ATR on Quality Control Check Report (Apartments)

Quality Control Check Report Stage: After Column Casting (villas)

QUALITY CONTROL COLUMN CHECK PLAN
(TYPE-A, WEST FACING)

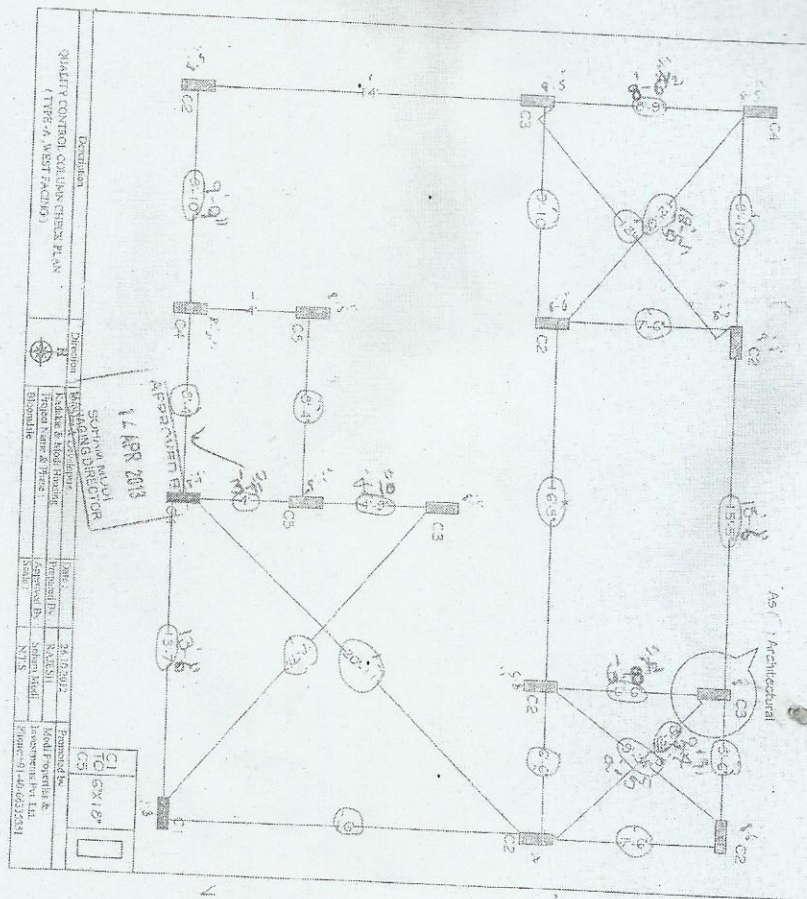
1. Error was on the parking column, which was error done by 1/2" in the 2nd floor and the ground floor it was 1".
